SSC Service Bulletin

no. 80-189

MODELS AFFECTED: MICRO COM BU SERIES

PROBLEM: NO TRANSMITTER DISABLE WITH MA-130 INSTALLED

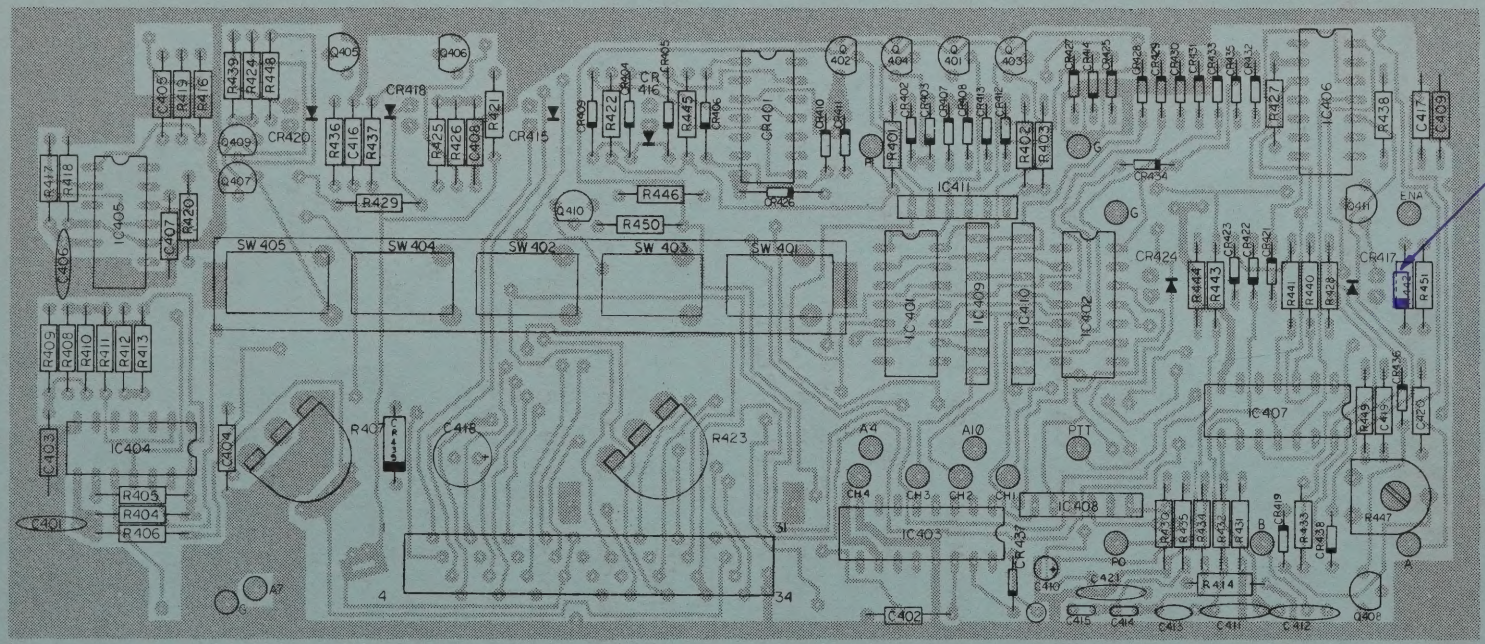
CURE: REPLACE R442 WITH DIODE (CATHODE TOWARDS THE BASE OF Q408), CR440, P/N 4805-1241-200 (SEE FIGURE 1)

REPLACE R442
WITH CR440
SW 405
SW 404
SW 402
SW 403
SW 401
IC401
IC402
IC403
IC404
IC405
IC406
IC407
IC408
IC409
IC410
IC411
R407
R423
C418
CR418
CR420
CR415
CR416
CR417
CR424
CR434
R429
R446
R450
Q410
Q409
Q407
Q405
Q406
Q401
Q402
Q403
Q404
Q411
Q408
A4
A10
PTT
CH4
CH3
CH2
CH1
A7
G
P0
P3
A
4
34
31

The schematic in the Service Manual should be brought up to a Rev. F. CR440 should be put in place of R442 on the schematic and last used block CR439 changed to CR440.
